Hanford Waste Management Area C WIR Evaluation 10-30-2018 DOE-NRC Teleconference Summary

The following topics regarding NRC's review of the Draft Waste Incidental to Reprocessing (WIR) Evaluation for Closure of Waste Management Area C (WMA C) at the Hanford Site were discussed during an October 30, 2018 teleconference.

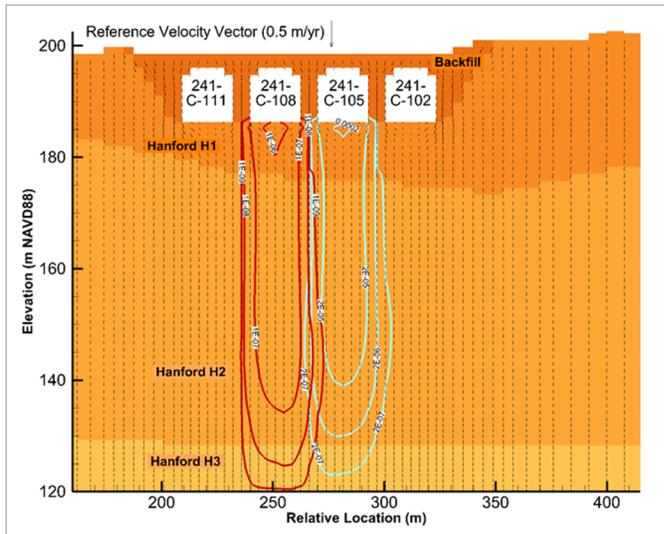
10. NRC staff asked if there will be any pipelines or transfer lines, especially plugged ones, not covered by the engineered surface barrier. DOE stated that closure cover has not yet been designed although the DOE staff did mention that the temporary cover would be similar to other intermediate covers in the Hanford Site and include an asphalt layer. Since the area outside of the WMA C is part of a CERCLA operable unit (200-IS-1),

DOE stated that they will provide access to a CERCLA document that discusses the pipelines in more detail.

Base Case Flow Field 1000 years after assumed closure

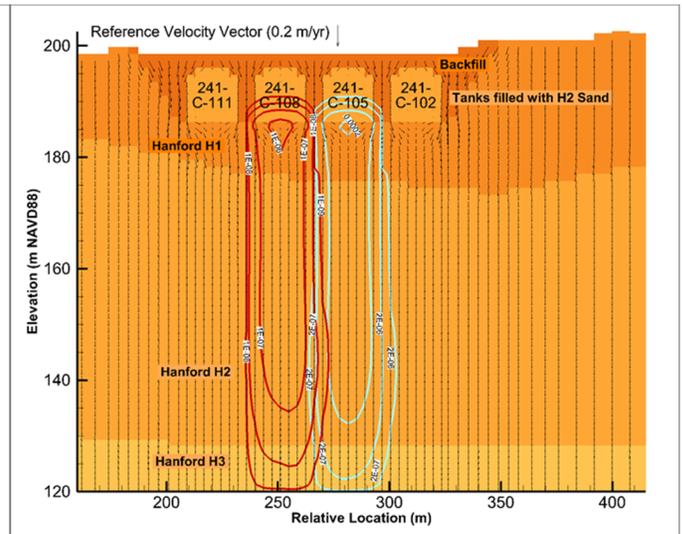
16. NRC staff asked DOE to discuss how the Darcy flux values were developed for the degraded grout sensitivity cases. DOE stated that the Darcy flux values were derived using a single STOMP simulation. In this STOMP model, the inactive area that in the base case represents the tanks was replaced with the properties of the H2 sand. DOE provided the below figure to aid the discussion and stated that the contrast in the material properties of the H2 sand and the backfill is such that infiltration is primarily diverted around the H2 sand (i.e. degraded tank grout) and into the backfill. DOE stated that flux and moisture content values from STOMP node 73 is used in the GoldSim model (as noted on p. 6-111). Node 73 is approximately 5 m above node 69. DOE stated that the STOMP model was run using the operational case to develop the initial conditions of the H2 sand that represented degraded tank grout. DOE stated that they would provide the GRT4 GoldSim file which was not provided with the other model files.

Photomosaic of Tank C-105

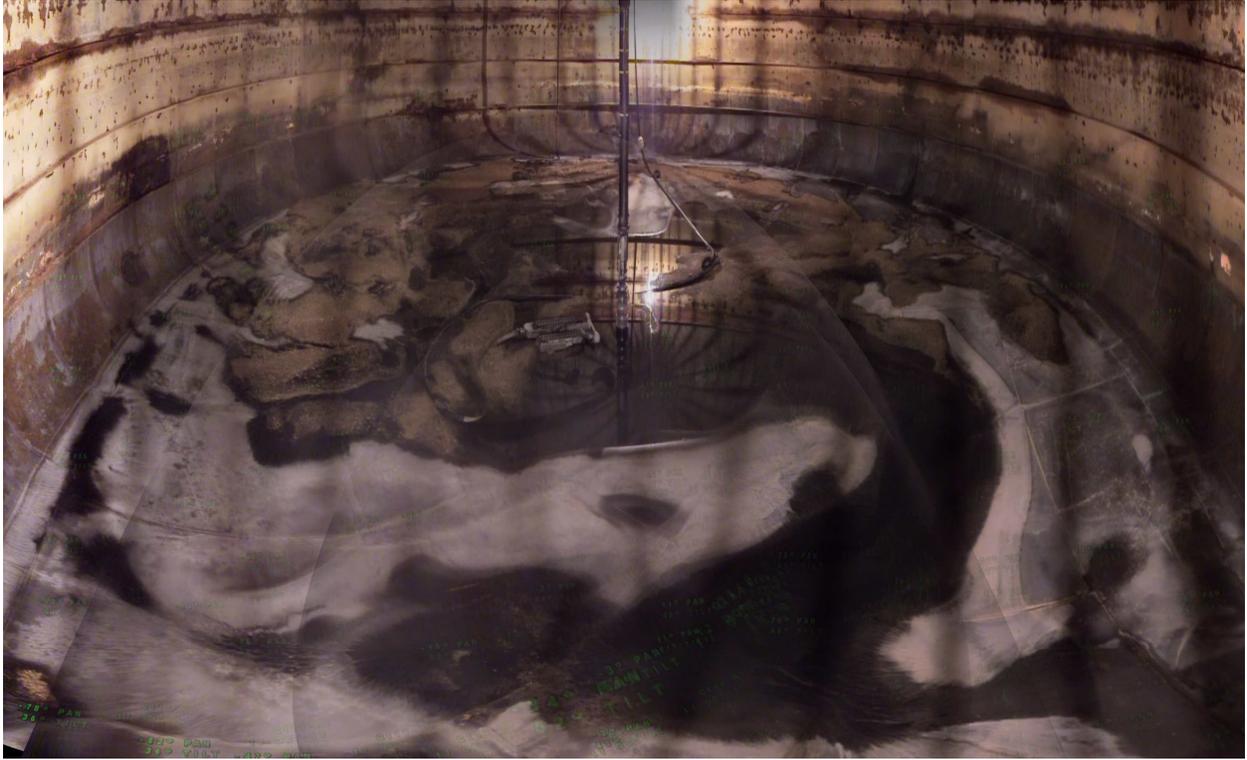
25. The residual equipment that will be left inside the tanks at closure was discussed. DOE stated that most of the items remaining inside the tanks are made of steel and that the remaining equipment represents approximately 0.1 to 0.2% of the tank volume with tank C-105 containing the most residual equipment. DOE would search for further information on the type and shape of the items remaining in the tanks as well as their composition. DOE stated that equipment remaining in the tanks will be taken into consideration at the time of closure and attempts to fill the equipment with grout will be made. DOE provided the below graphics to aid the discussion on residual equipment.
